## INSTRUCTIONS FOR REPLACING OIL SEAL IN SCRAMBLER PINION CASTING ASSEMBLY

# UNIT POLE MODIFICATION

# SAFETY      BULLETIN

# INSTALLATION OF OVERSPEED SWITCH FOR ALLIS-CHALMERS ENGINE

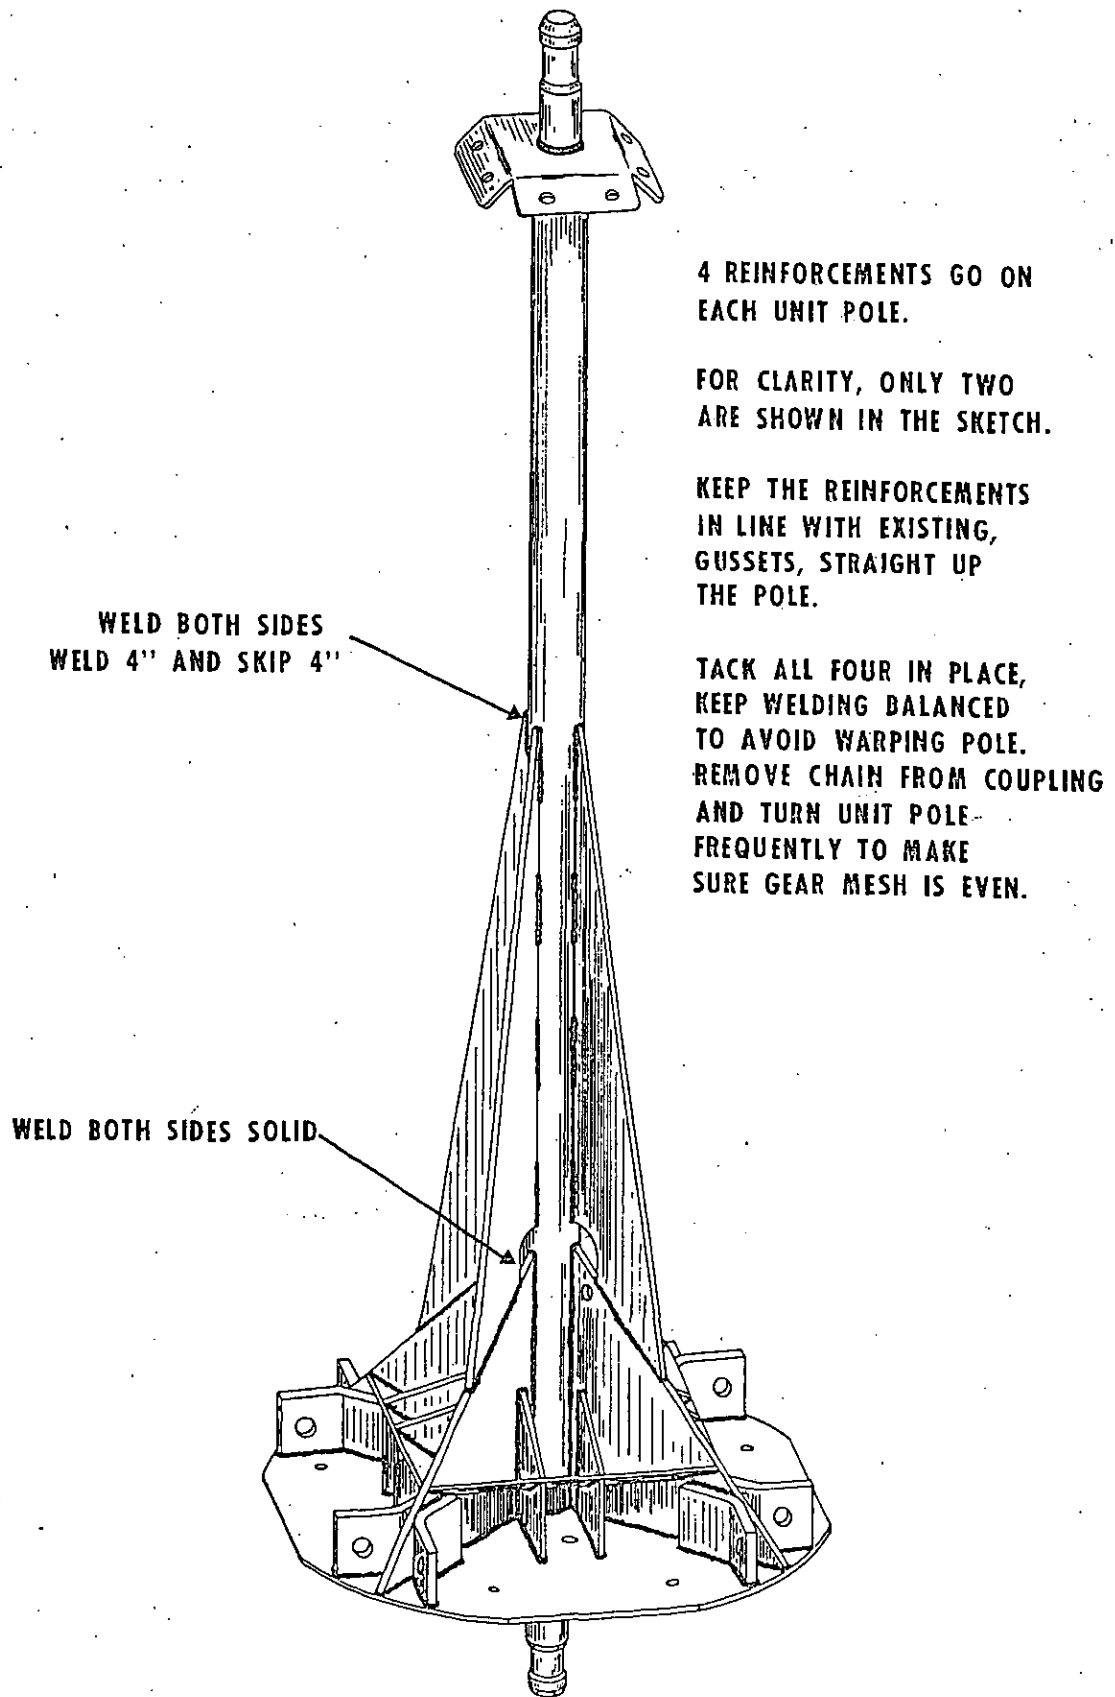
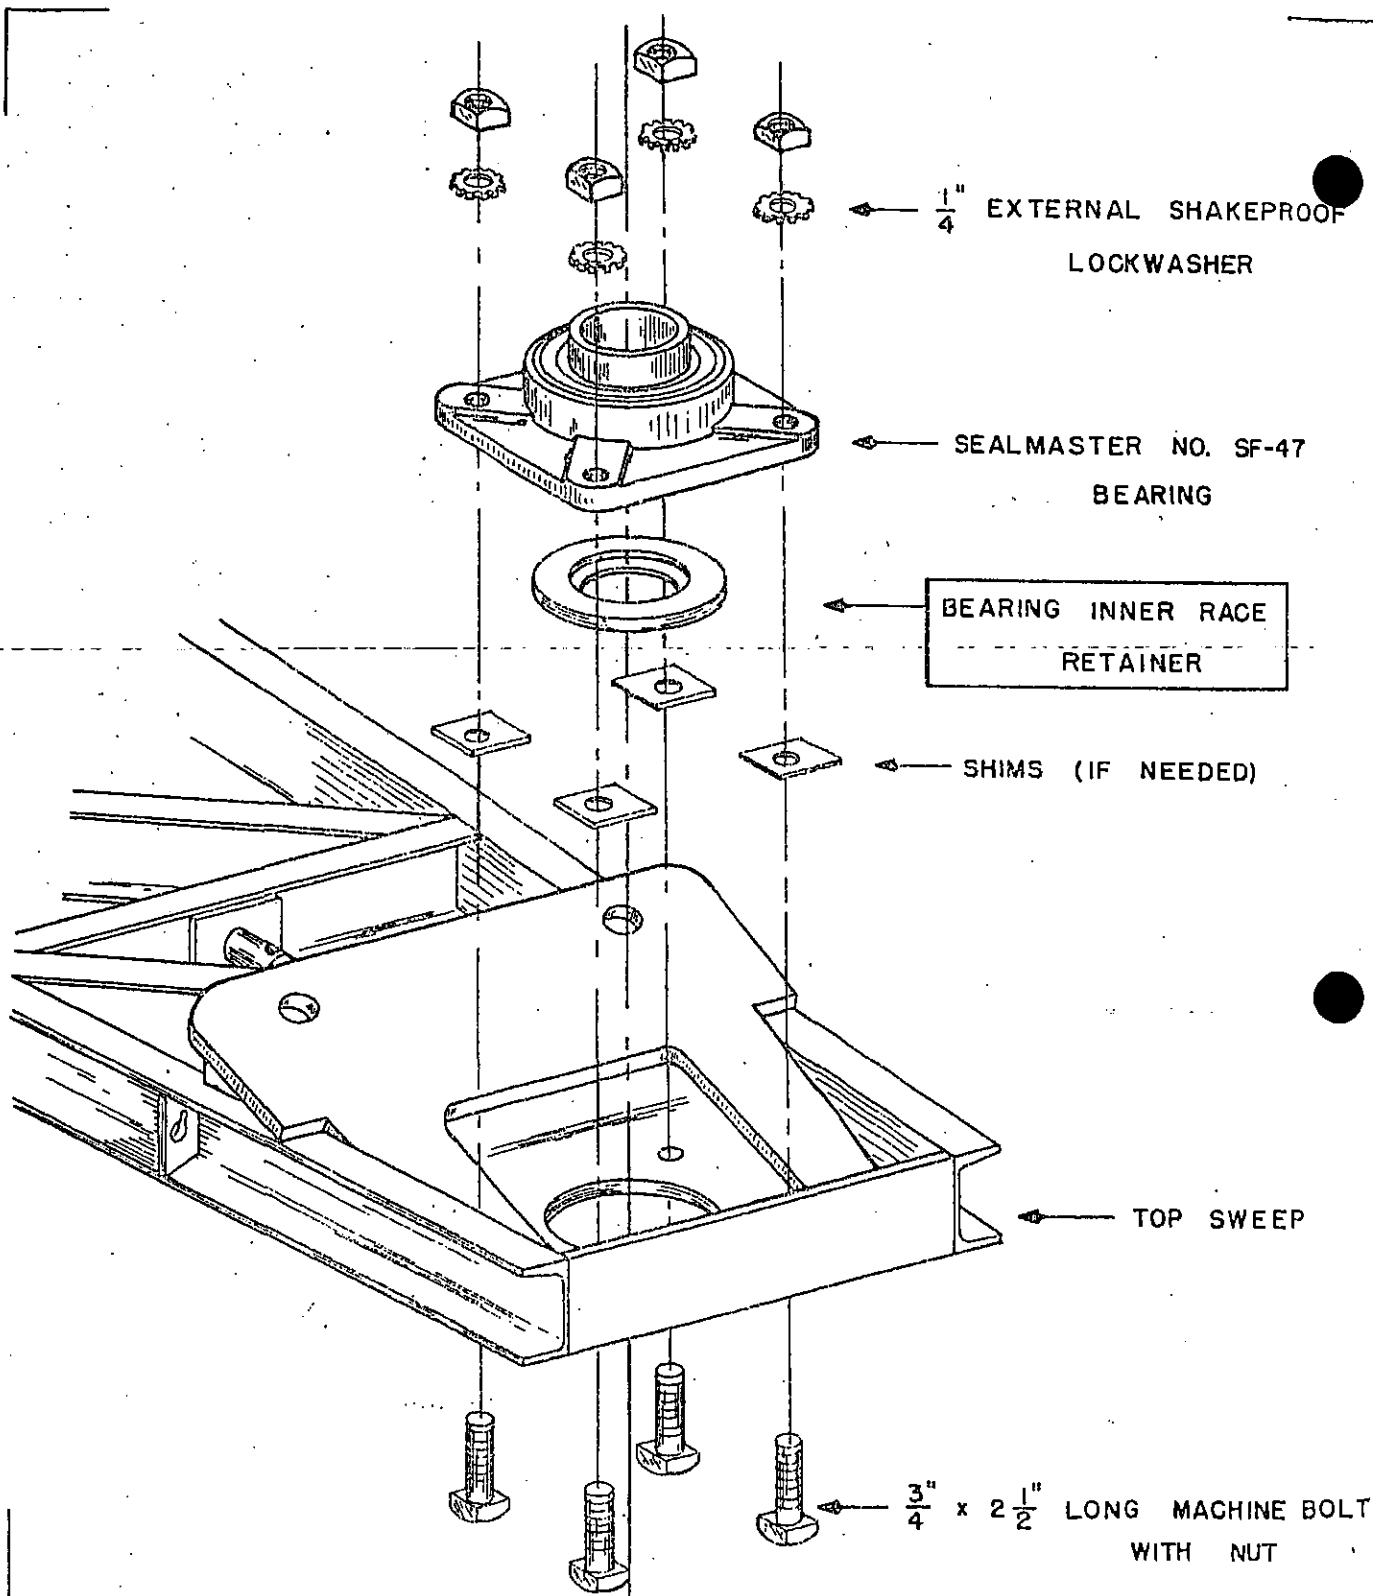
In limited instances it has been reported to us that a slight crack, and even a complete break, has occurred in one or more of the three Unit Poles of a Scrambler ride. When this happens it can be a severe hazard to any passengers who may be riding at the time.

In all cases known to us the crack or break has occurred immediately above the top of the four gusset plates of the Unit Pole. Due to the seriousness and similarity of this problem, we turned the matter over to an outside firm of consulting engineers for critical study and solution. Their investigation revealed that this failure is caused by operation of the ride at speeds in excess of that which is recommended by Eli Bridge Company.

To avoid this problem in the future, the consulting engineers have made two recommendations. First, DO NOT allow your operator to "goose" the ride to speeds in excess of those recommended by the factory (the centerpole of the ride should not turn more than 11 rpm when powered with gasoline motor, or, 11.4 rpm when powered with electric motor). Second, they have strongly recommended that all Scrambler rides presently in operation be equipped with additional gusset plates, as shown on the attached drawing. These extensions to existing gusset plates are designed to give the Unit Poles proper strength and safety - even though a crack may have already begun to form immediately above the original gussets.

4 REINFORCEMENTS GO ON EACH UNIT POLE.

KEEP THE REINFORCEMENTS IN LINE WITH EXISTING, GUSSETS, STRAIGHT UP THE POLE.

TACK ALL FOUR IN PLACE, KEEP WELDING BALANCED TO AVOID WARPING POLE. REMOVE CHAIN FROM COUPLING AND TURN UNIT POLE FREQUENTLY TO MAKE SURE GEAR MESH IS EVEN.

# DIRECTIONS FOR INSTALLING A SECONDARY LATCH ON A SCRAMBLER RIDE SEAT

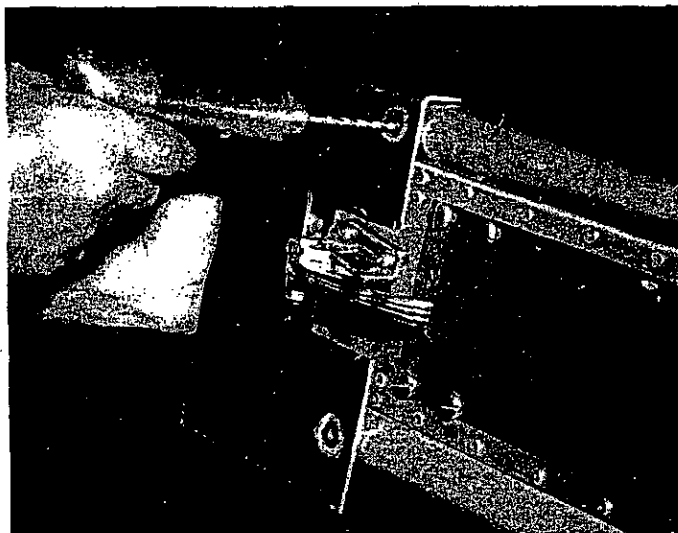
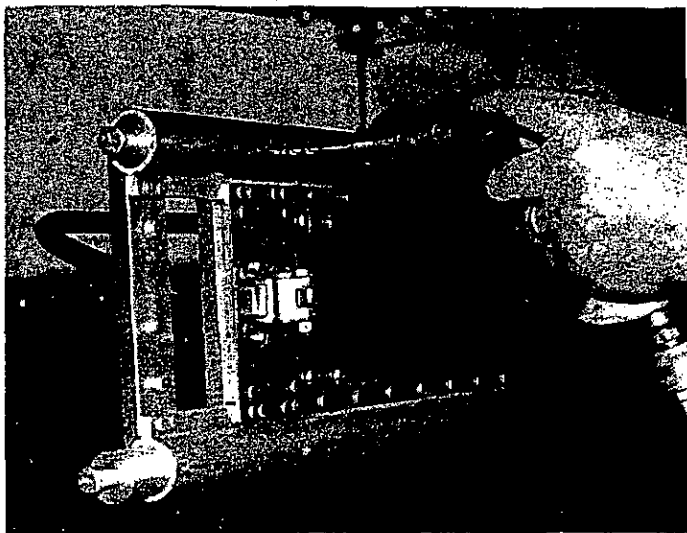
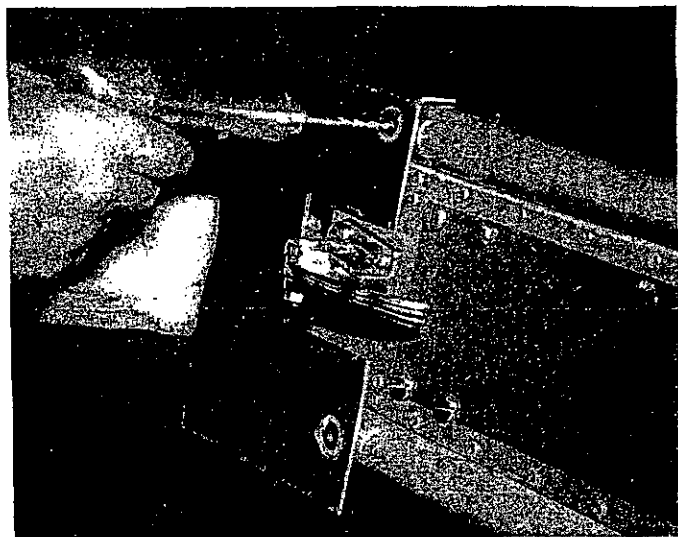
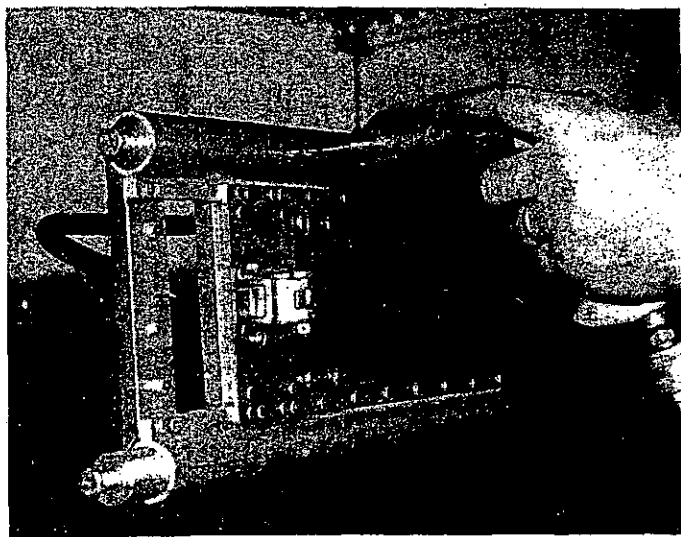
In 1973 it became mandatory in the State of California that rides such as the BIG ELI Scrambler ride be equipped with secondary latching devices on the seats, in addition to the normal primary latch. It was intended that this secondary latching device prevent the handlebar from opening, or being easily opened, even if the primary locking device should fail to function.

1. Use a 5/32" punch to push out the roll pin holding each rounded knob in the end of the handlebar, as shown in Picture No. 1. Then remove the knobs.
2. Hook the handlebar drill template over the top of the handlebar and butt it against the outer end of the handlebar as shown in Picture No. 2. With a 3/16" drill, drill a hole through the front side of the tube at the top of the handlebar, and then do the same with the tube at the bottom of the handlebar. These two holes in the template are encircled in the Picture. CAUTION: DO NOT DRILL THROUGH THE BACK SIDES OF THE TUBES.

3. Each long plug has a 3/8" hex head bolt screwed in the end. Insert the plug into the tube of the handlebar, and shove it in until it is flush with the outer end of the handlebar. Turn the plug around until you can see the hole in the plug through the hole you have just drilled in the tube. Line up these two holes as well as you can. Insert the 3/16" drill all the way in and finish drilling through the back side of the tube, as shown in Picture No. 3. In this way the hole will be lined up all the way through. Install the round head, 10-24 screw, 1-1/2" long, through the hole and secure it with a self-locking nut.

4. Lay the skin template against the side of the seat and locate it in position by inserting the stem of a rivet through the only hole that is in a corner of the template, and then insert the stem of the rivet through the hole in the rivet head in the top front corner of the seat. Line up the front edge of the template with the front edge of the seat, and insert the stem of a second rivet through the other hole in the front edge of the template and into the hole in the rivet head underneath the template. This locates the template accurately. There are four holes remaining in the template. Using a No. 20 drill, drill one of the holes into the seat skin, and slip a rivet through the template and seat skin to keep them lined up. DO NOT SET THIS RIVET. Then drill the second hole, which is near the first hole. See Picture No. 4. Repeat the procedure with the other two holes.

5. Remove the template and install the two brackets on the side of the seat. The top bracket is the long one, and the hook must be on the bottom side. On the bottom bracket the hook must be on the top side. The two holes located by the template for each bracket are for the top front and bottom rear rivet of each bracket. Set the two 5/32" rivets in each bracket. See Picture No. 5.

6. With a No. 20 drill, drill through the remaining four holes in the top bracket to locate matching holes in the seat skin, and then do the same with the three in the bottom bracket. Then install the 5/32" rivets.
7. Install the chain with the end link laid on top of the bracket and pointed straight out, away from the seat. The round head of the 10-24 screw (3/4" long) and the washer go on the top of the chain link, and the self-locking nut goes underneath the bracket.
8. Install the handlebar bracket on the end of the handlebar with the two 3/8"-16 hex head bolts, 1" long, and be sure there is an internal lockwasher under the head of each bolt.
9. The locking pin will drop in place freely if all parts have been installed correctly.
10. This completes the installation of the secondary latch, and it is shown in Picture No. 6.
